Dry Hill Park Road Junction with B245 London Road Improvements to Pedestrian Crossing Facilities

Options Report

Document reference: CO04300072/002

Stage 1 Road Safety Audit

Drawing number TON/CRM/DRYHILL/RSA/OPT 1 **Rev** 0

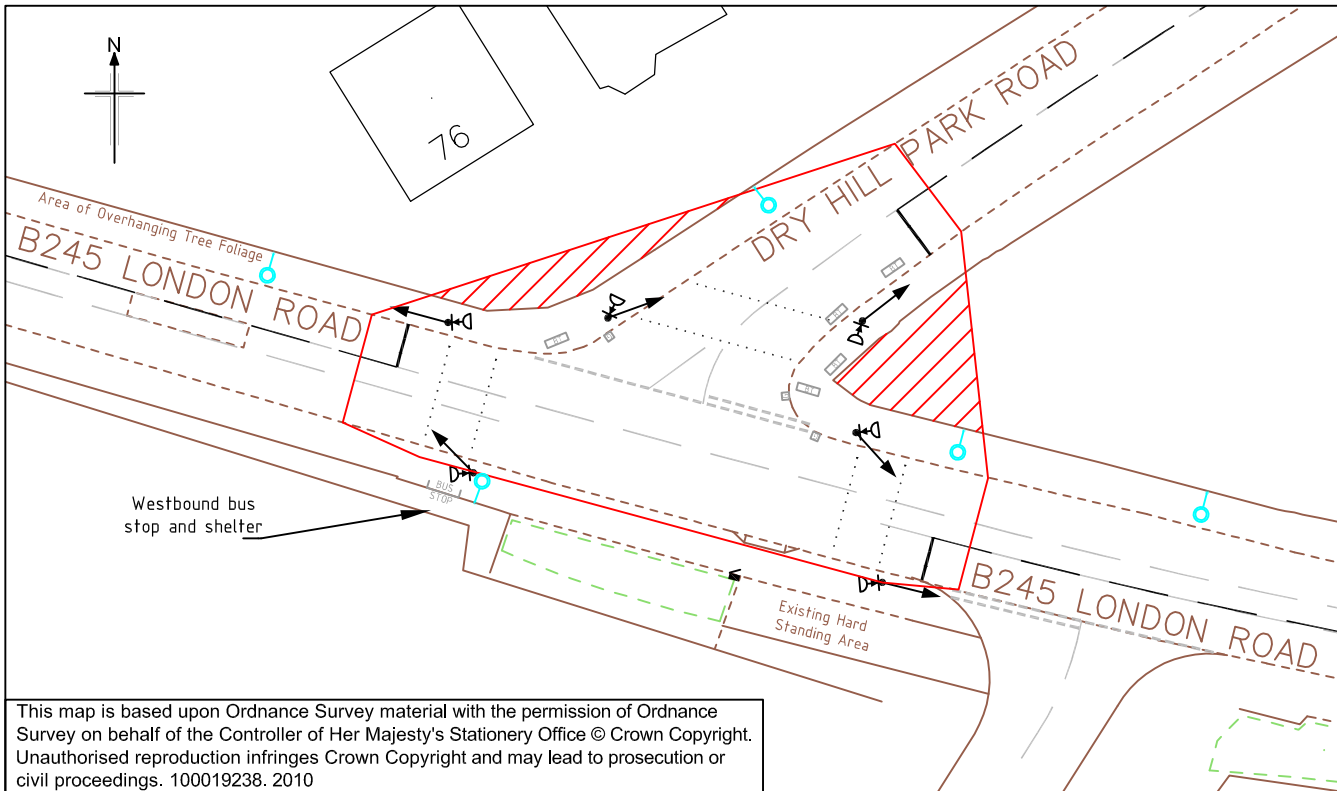
2	ITEMS RAISED AT THIS STAGE 1 AUDIT
2.1	<p data-bbox="272 188 419 219">PROBLEM</p> <p data-bbox="272 255 775 286">Location: Area of zebra crossing itself</p> <p data-bbox="272 322 1465 421">Summary: Proximity of zebra crossing to junctions with Dry Hill Park Road and the entrance to the Tonbridge school play fields will result in late recognition of the crossing</p> <p data-bbox="272 456 1465 725">The proposed crossing will be placed immediately east of the junction with Dry hill Park Road. The proximity of the junction and the presence of the junction to playing fields on the southern side will require drivers to be aware of these junctions particularly the junction of Dry Hill Park Road where vehicles struggle to pull out. This problem is exacerbated by high vehicle speeds through this area; certainly in excess of the 30mph speed limit. Any pedestrian stepping out onto the crossing is at serious risk of being struck by a vehicle pulling out of either junction, often at high speed due to the need to pull out quickly into a gap in the traffic.</p> <p data-bbox="272 761 560 792">RECOMMENDATION</p> <p data-bbox="272 828 1465 958"><i>It is recommended</i> that provision of a zebra crossing at this location be seriously reconsidered. An alternative might be to signalise the junction itself with an associated pedestrian phase in the sequencing. This would improve safety for pedestrians as well as improving traffic flow through the junction.</p>

Item No.	Issues Identified and Their Recommendations	Design Project Manager Response	Scheme Promoters Decision And Proposed Action
2.1	<p>PROBLEM</p> <p>Location: Area of zebra crossing itself</p> <p>Summary: Proximity of zebra crossing to junctions with Dry Hill Park Road and the entrance to the Tonbridge school play fields will result in late recognition of the crossing</p> <p>The proposed crossing will be placed immediately east of the junction with Dry Hill Park Road. The proximity of the junction and the presence of the junction to playing fields on the southern side will require drivers to be aware of these junctions particularly the junction of Dry Hill Park Road where vehicles struggle to pull out. This problem is exacerbated by high vehicle speeds through this area; certainly in excess of the 30mph speed limit. Any pedestrian stepping out onto the crossing is at serious risk of being struck by a vehicle pulling out of either junction, often at high speed due to the need to pull out quickly into a gap in the traffic.</p>

<p>RECOMMENDATION</p> <p><i>It is recommended</i> that provision of a zebra crossing at this location be seriously reconsidered. An alternative might be to signalise the junction itself with an associated pedestrian phase in the sequencing. This would improve safety for pedestrians as well as improving traffic flow through the junction.</p>			
--	---	--	--	--

Drawing Title
**Pedestrian Crossing - Option 2
Zebra Crossing**

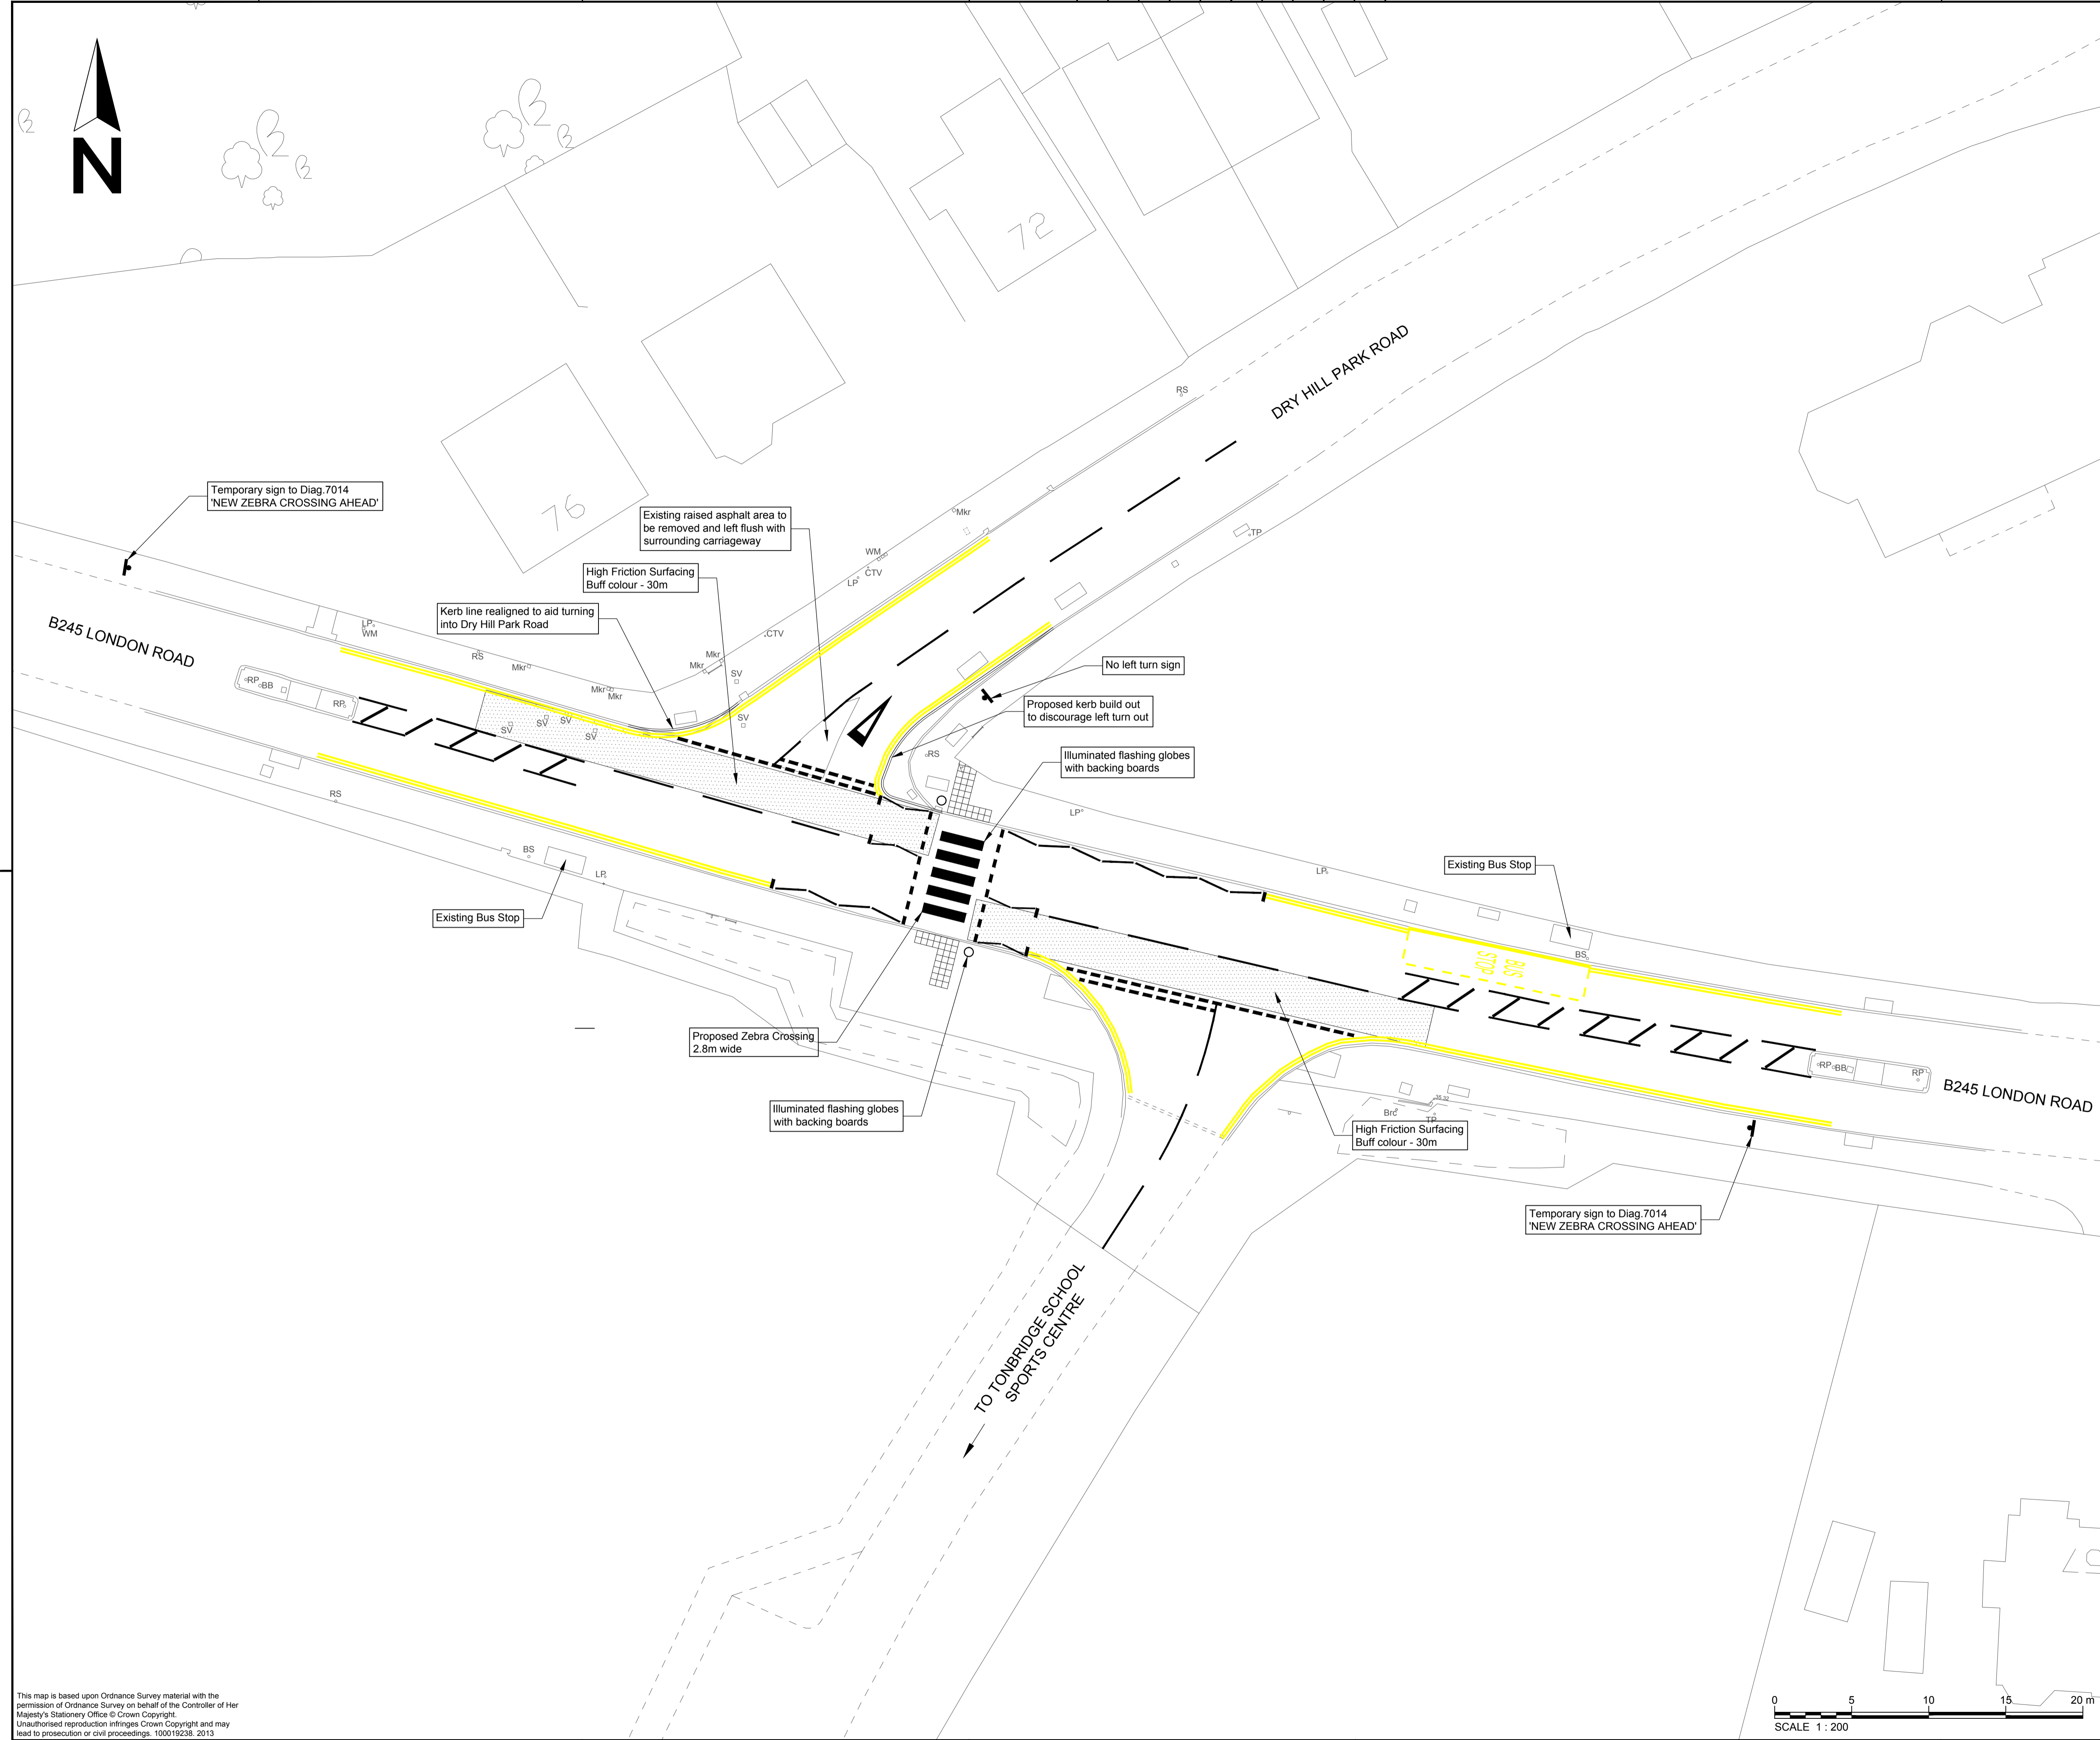
2	ITEMS RAISED AT THIS STAGE 1 AUDIT
2.1	<p>COMMENT – BOTH OPTIONS</p> <p>Location: Junction of Dry Hill Park Road and London Road</p> <p>Summary: The proposed build out to deter vehicles turning left will play a significant part in preventing illegal turns but not assist turning positions.</p> <p>Opportunity should be taken when building the kerb build out to realign the junction straightening out the eastern corner of Dry Hill Park Road and curving the centre line marking to the west. This will allow vehicles to align better for the right turn. It was observed during the site visit that vehicles often positioned themselves incorrectly causing a delay in the turning movement.</p> <p>RECOMMENDATION</p> <p><i>It is recommended</i> that the junction be modified aligning traffic in the southbound lane at an increased angle by about 10-20 degrees.</p>

Item No.	Issues Identified and Their Recommendations	Design Project Manager Response	Scheme Promoters Decision And Proposed Action
2.1	<p>COMMENT – BOTH OPTIONS</p> <p>Location: Junction of Dry Hill Park Road and London Road</p> <p>Summary: The proposed build out to deter vehicles turning left will play a significant part in preventing illegal turns but not assist turning positions.</p> <p>Opportunity should be taken when building the kerb build out to realign the junction straightening out the eastern corner of Dry Hill Park Road and curving the centre line marking to the west. This will allow vehicles to align better for the right turn. It was observed during the site visit that vehicles often positioned themselves incorrectly causing a delay in the turning movement.</p> <p>RECOMMENDATION</p> <p><i>It is recommended</i> that the junction be modified aligning traffic in the southbound lane at an increased angle by about 10-20 degrees.</p>

Table 2: Stage 1 Safety Audit			
Comment	Option	Recommendation	Designer Comment
<p>Location: Junction of Dry Hill Park Road and London Road</p> <p>Summary: The proposed build out to deter vehicles turning left will play a significant part in preventing illegal turns but not assist turning positions.</p> <p>Opportunity should be taken when building the kerb build out to realign the junction straightening out the eastern corner of Dry Hill Park Road and curving the centre line marking to the west. This will allow vehicles to align better for the right turn. It was observed during the site visit that vehicles often positioned themselves incorrectly causing a delay in the turning movement.</p>	2 and 3	<p>It is recommended that the junction be modified aligning traffic in the southbound lane at an increased angle by about 10-20 degrees.</p>	<p>We believe that the auditor's comments suggest that an increased skewed approach to the junction will provide a better turning position. However, we do not believe this to be the case due to increased difficulties of seeing approaching vehicles from the right, particularly large vehicles and suggest that moving the centreline slightly to the east to create a better perpendicular approach to the junction should be adopted. This follows the guidance in TD42/95 for having perpendicular approaches to junctions.</p>

Drawing Title
**Pedestrian Crossing - Option 3
 Pedestrian Refuge Island**

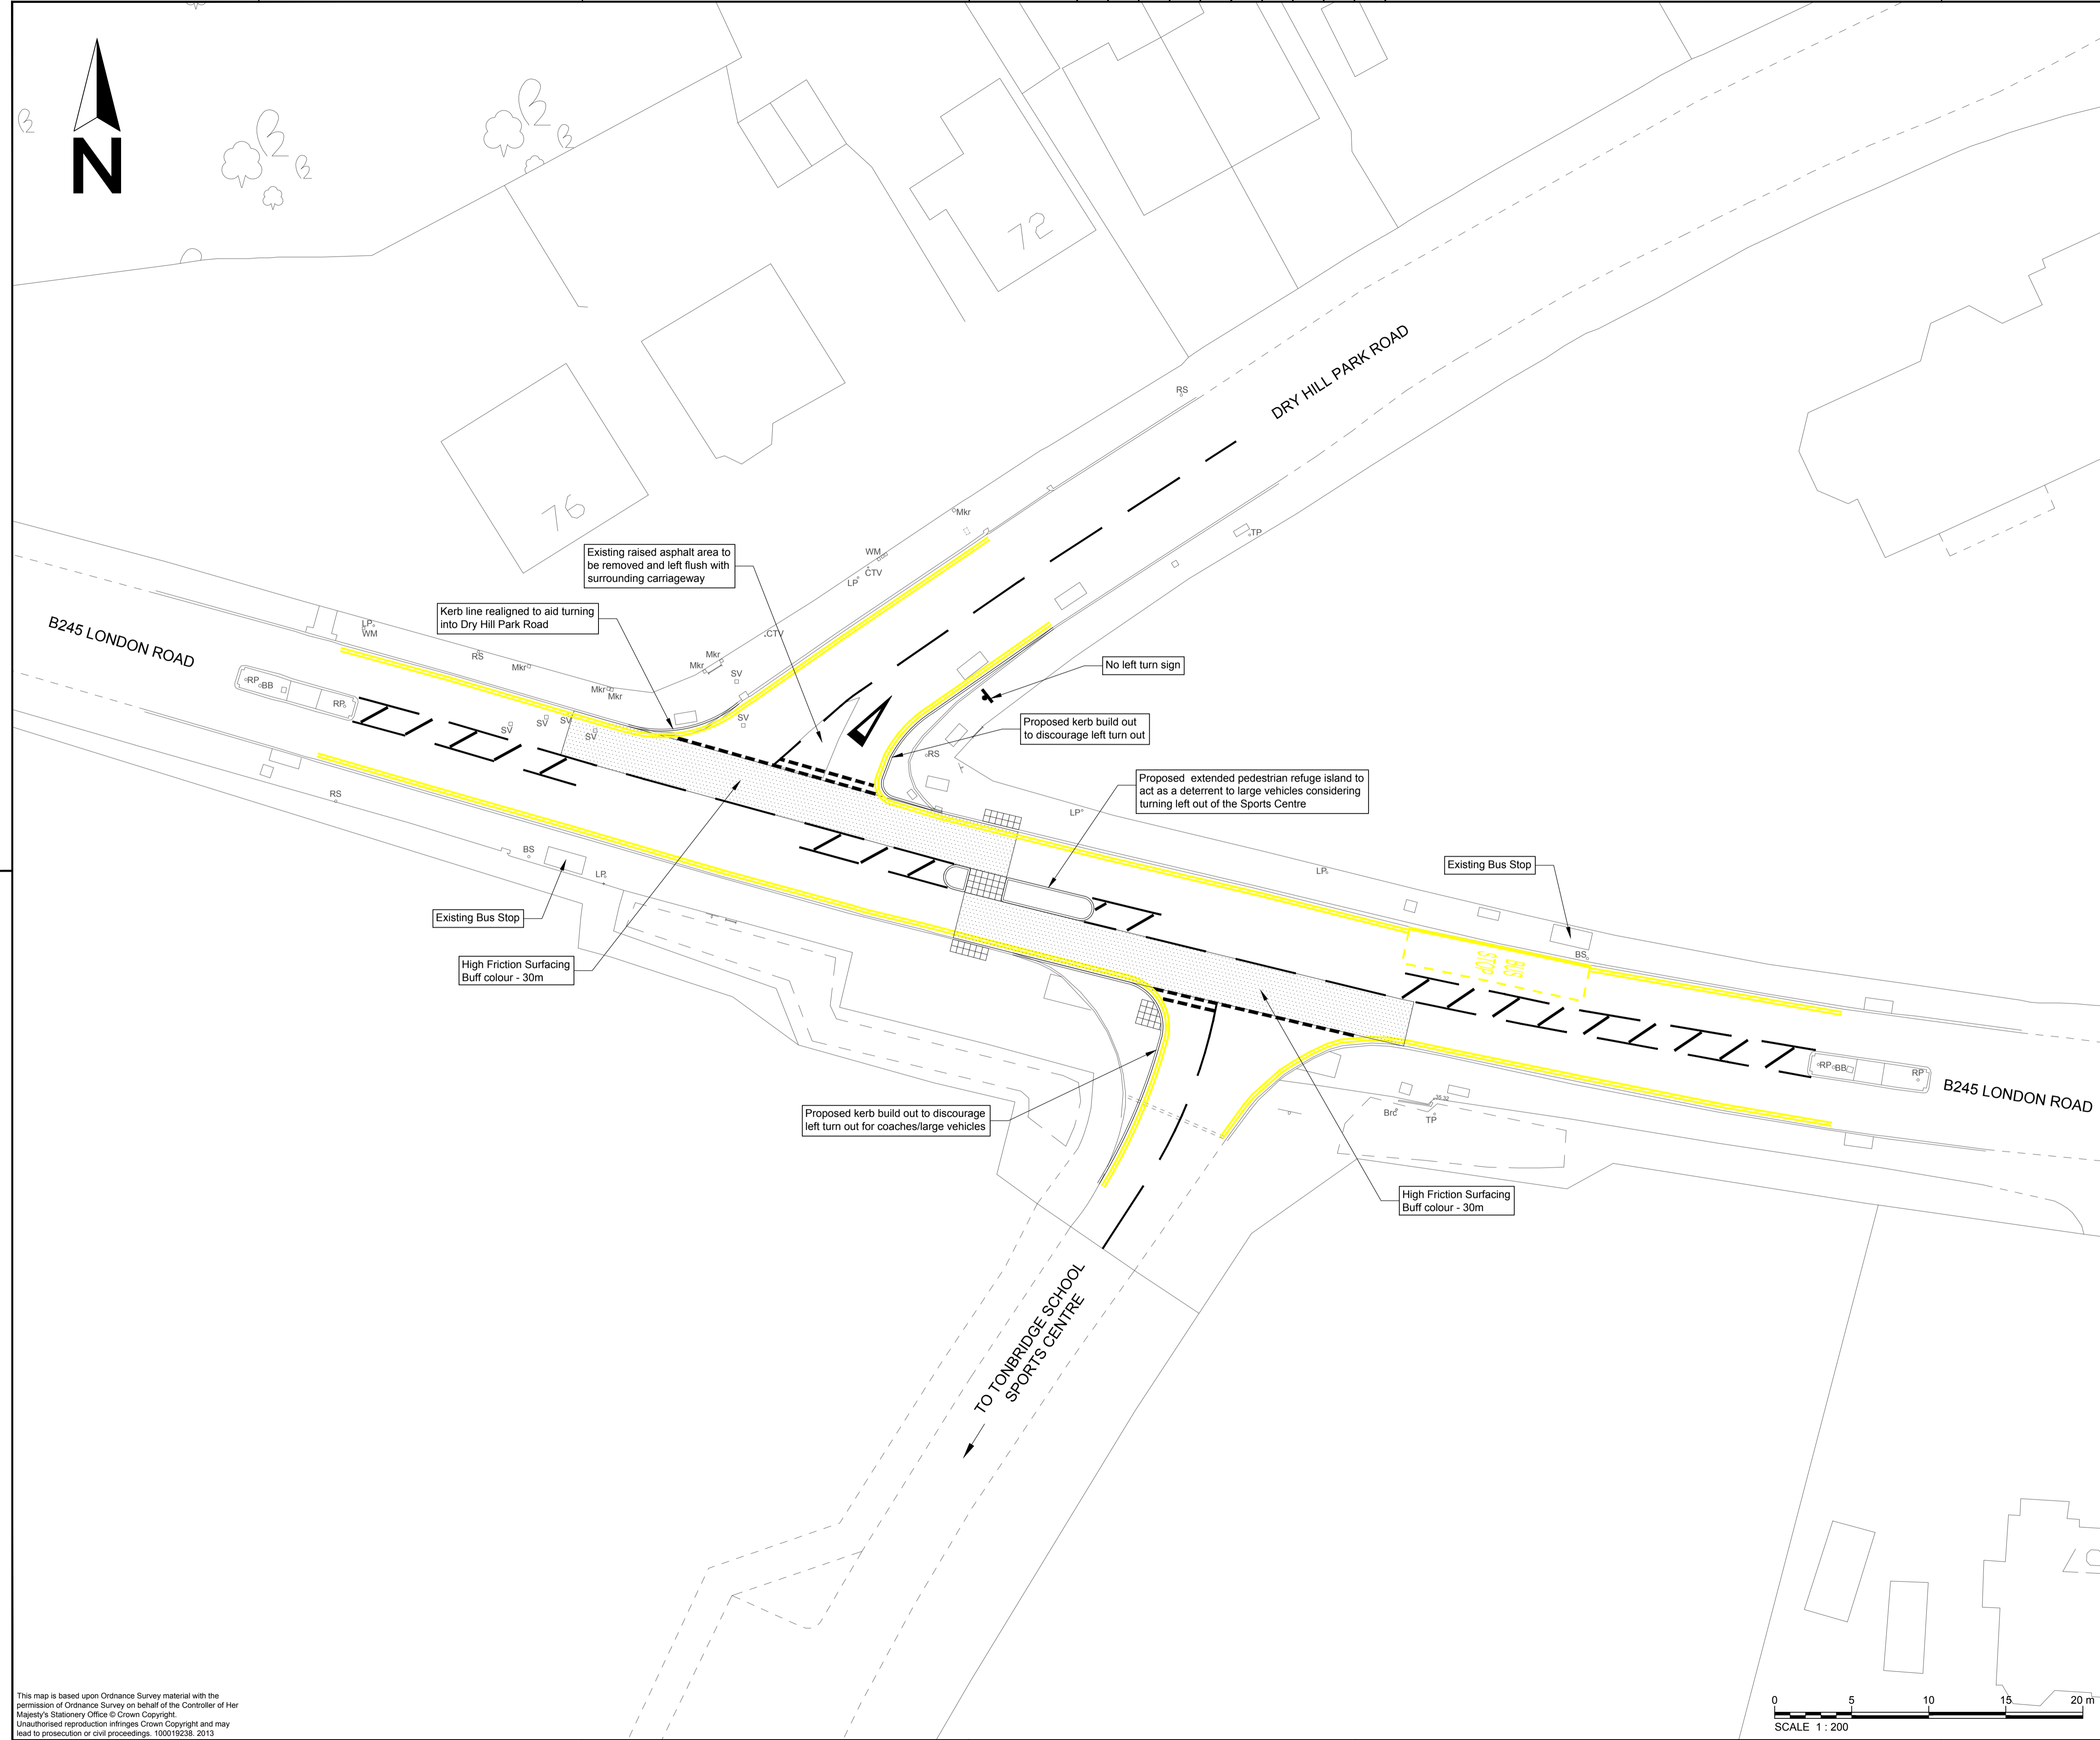
2.2	<p>COMMENT – OPTION PED REFUGE ISLAND</p> <p>Location: London Road east of junction</p> <p>Summary: The proposed pedestrian island is not shown as having high visibility beacon.</p> <p>The new pedestrian island will play an important part in preventing illegal turns. However no information is given as to its construction. Due to the location and speed of vehicles it is important that this facility is highly visible to all motorists.</p> <p>RECOMMENDATION</p> <p><i>It is recommended</i> that the pedestrian island is constructed to current KCC standard design with high visibility beacon and reflectorized keep left arrows on the far end of the island itself.</p>

2.2	<p>COMMENT – OPTION PED REFUGE ISLAND</p> <p>Location: London Road east of junction</p> <p>Summary: The proposed pedestrian island is not shown as having high visibility beacon.</p> <p>The new pedestrian island will play an important part in preventing illegal turns. However no information is given as to its construction. Due to the location and speed of</p>

<p>vehicles it is important that this facility is highly visible to all motorists.</p> <p>RECOMMENDATION</p> <p><i>It is recommended</i> that the pedestrian island is constructed to current KCC standard design with high visibility beacon and reflectorized keep left arrows on the far end of the island itself.</p>			
--	---	--	--	--

<p>Location: London Road east of junction</p> <p>Summary: The proposed pedestrian island is not shown as having high visibility beacon.</p> <p>The new pedestrian island will play an important part in preventing illegal turns. However no information is given as to its construction. Due to the location and speed of vehicles it is important that this facility is highly visible to all motorists.</p>	3	<p>It is recommended that the pedestrian island is constructed to current KCC standard design with high visibility beacon and reflectorized keep left arrows on the far end of the island itself.</p>	<p>The islands will be designed and constructed to current standard including high visibility beacons and keep left arrows.</p>
